World Forum for Harmonization of Vehicle Regulations**Working Party on General Safety Provisions****127th session**

Awareness of the Proximity of Vulnerable Road Users:**UN Regulation No. 166 (Vulnerable Road Users in Front and Side Close Proximity)****Proposal for the 01 Series of Amendments to UN Regulation
No. 166 (Vulnerable Road Users in Front and Side Close
Proximity)****Submitted by the expert from Japan ***

Figure 1
Example for the measurement by maximum variation

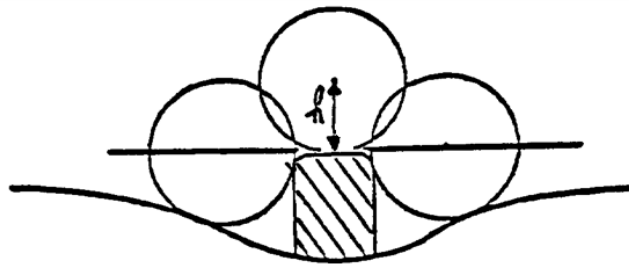
- 6.1.3.3.2. If the dimension of the projection of a component which is mounted on a surface other than convex cannot be determined by simple measurement, it shall be determined by the maximum variation of the distance of the centre of a 100 mm diameter sphere from the nominal line of the panel when the sphere is moved over and is in constant contact with that component.
Figure 1 shows an example of the use of this procedure.

Figure 2
Dimensions of the Test Rig and the Special Design
 (in millimeters)

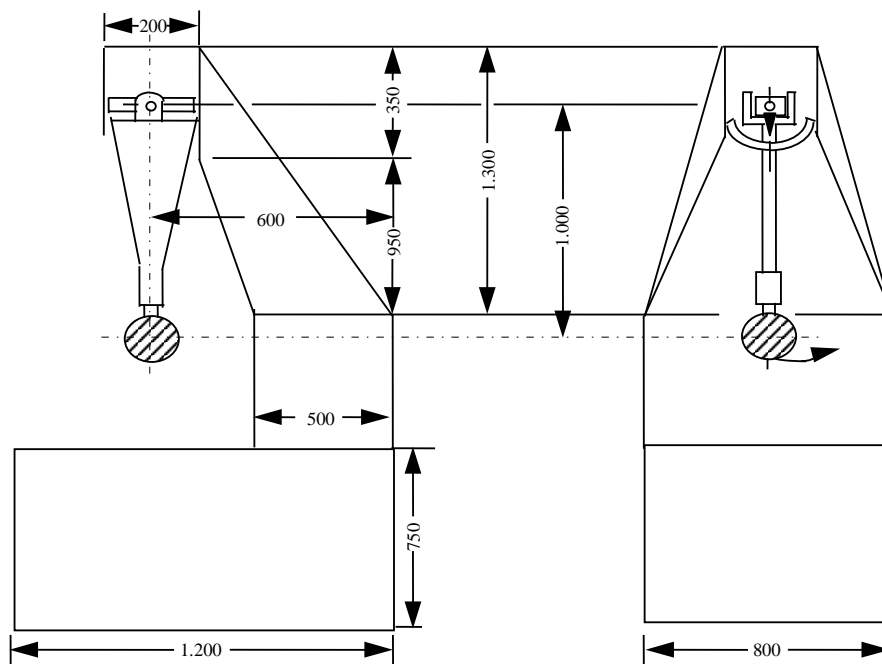
Figure 2 below gives the dimensions (in mm) of the test rig and the special design specifications:

Figure 3
Example of Mirror Bending-Test Rig

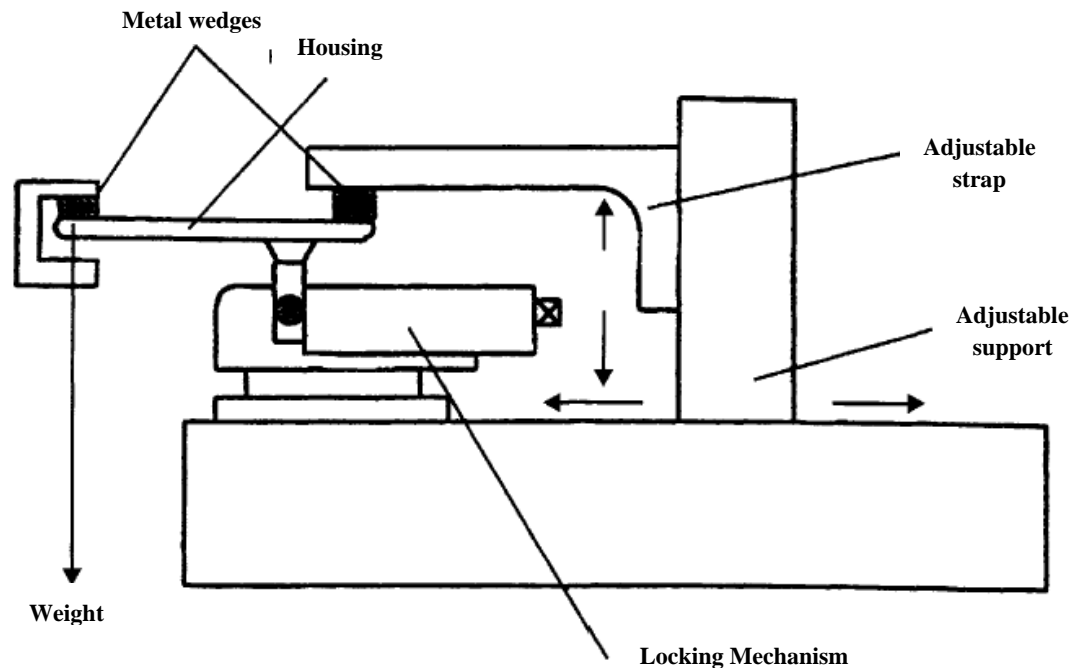
At the other end, a stop identical to the one described above is placed on the housing so that the specified test load can be applied to it (Figure 3).

The end of the housing opposite to that where the force is exerted may be locked rather than held in position as shown in Figure 3.

Figure 5
Examples of Designated Area of Each Means (Right-Handed Drive Case)

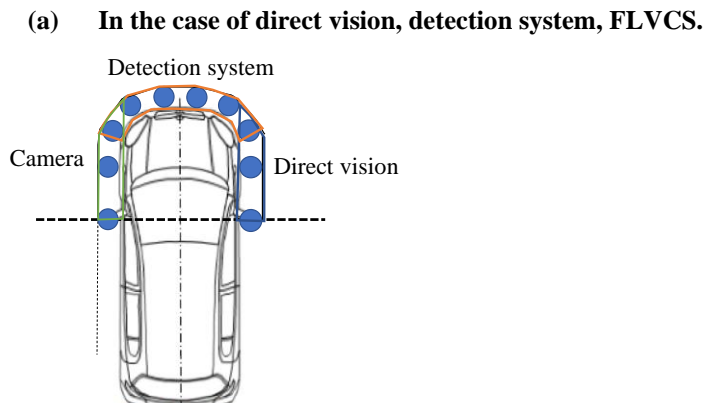
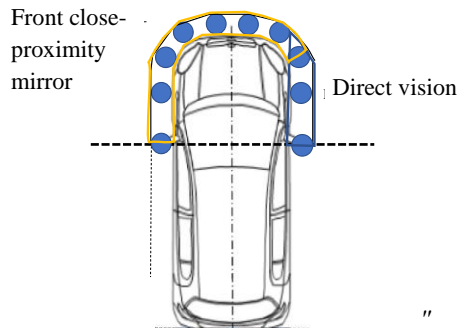
Overlaps of designated areas by different means (see examples in Figure 5) shall be permitted.

5. Paragraphs 15.1., 15.2. and 15.2.1.:
Reorganized between two paragraphs 15.1 and 15.2 for misunderstanding and for clear descriptions. The figures on pole location at the centre of the side mirror were updated to avoid misinterpretation.

Figure 6
Close-Proximity Front and Lateral Sides View Field of Vision

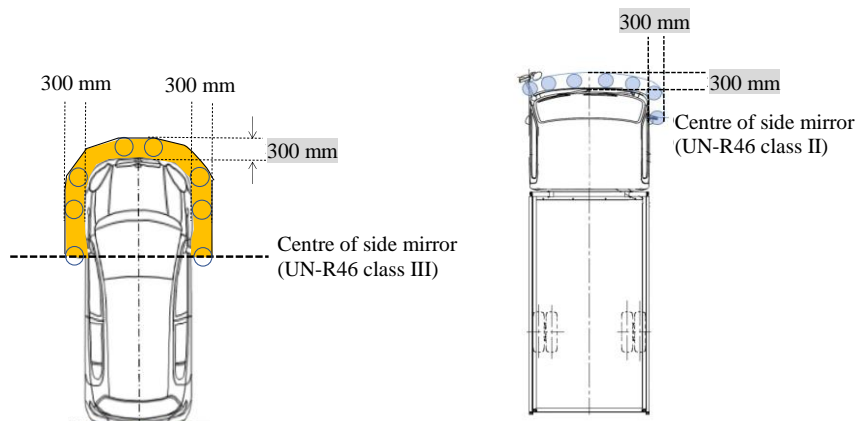
Paragraph 15.2., delete Figure 2 and amend to read:

The field of vision (see Figure 2 6 below) shall be bounded by the following planes:

- (a) A ~~longitudinal~~ **transverse** vertical plane passing through a point 300 mm from the contour of the sides of the vehicle;
- (b) A transverse ~~vertical~~ **horizontal** plane passing through a point 300 mm from the contour of the front of the vehicle;
- (c) Areas ahead of the centre of the side mirrors on the driver's seat side and the passenger seat side. In the case of the vehicle that equipped with CMS that comply UN Regulation No. 46, 04 Series of amendments, the manufacturer shall consider the same vehicle equipped with side mirrors or to use the centre of Class III or II CMS camera lens instead of the centre of the side mirrors.

Figure 7
Example for the Measurement by Maximum Variation

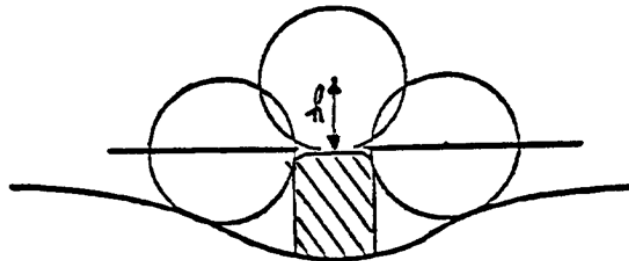
- 15.4.3.3.2.** If the dimension of the projection of a component which is mounted on a surface other than convex cannot be determined by simple measurement, it shall be determined by the maximum variation of the distance of the centre of a 100 mm diameter sphere from the nominal line of the panel when the sphere is moved over and is in constant contact with that component.
Figure 7 shows an example of the use of this procedure.

Test Object Locations

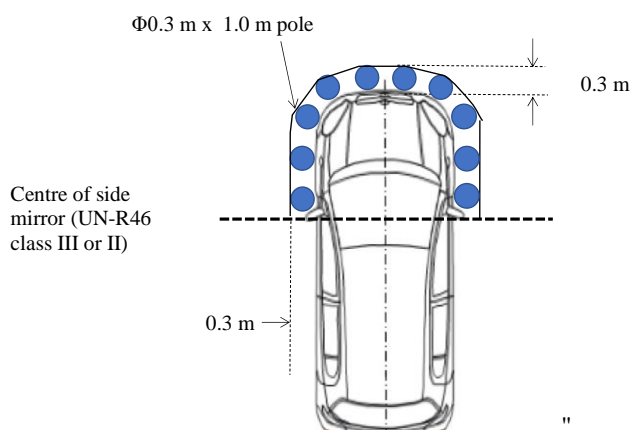
- "1.2. The test object shall be in contact with the vehicle's front and lateral side from the centre of passenger side mirror to driver's side mirror shall be seen in the close-proximity front and lateral view field of vision. In the case of the vehicle that equipped with CMS that comply UN Regulation No. 46, 04 Series of amendments, the manufacturer shall consider the same vehicle equipped with side mirrors or to use centres of Class **III** or II CMS camera lens instead of the centres of the side mirrors.

10. Annex 9:
Add the description for the Class II mirror in the figure.
 11. Annex 10:
Remove sentences for clarification
 12. Annex 13:
Reflects the latest amendment of UN Regulation No. 46 (GRSG-126-24r1).
-

Necessity of Pendulum Impact Test

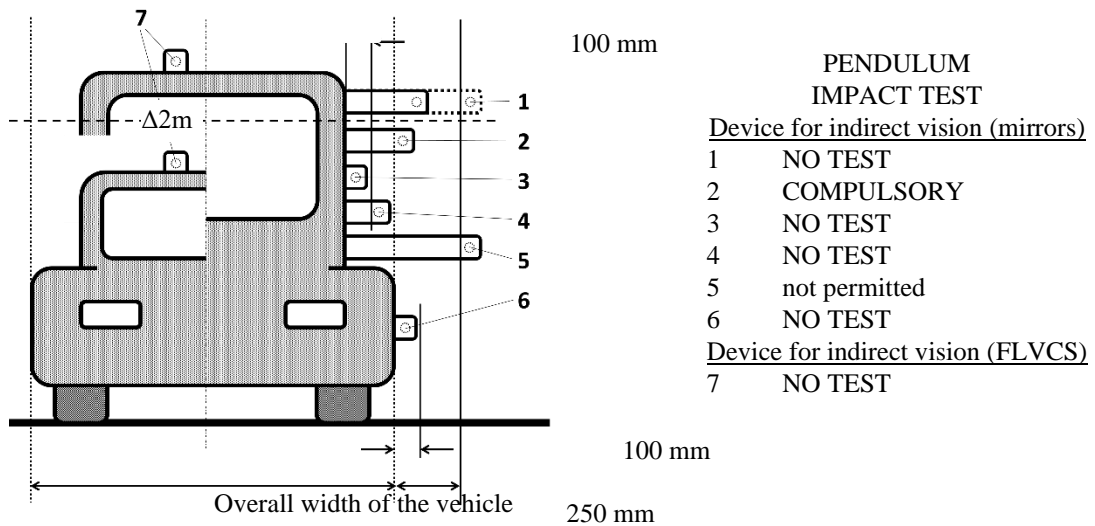
- (a) exterior devices not projecting beyond the overall width and length of the vehicle and providing a frontal deflecting area of an angle not more than 45° measured in relation to the longitudinal median plane of the vehicle; or
- (b) devices not protruding more than 100 mm measured at the attachment point beyond the circumscribing external original surface of the vehicle according to UN Regulation No. 26 (See Annex 13).
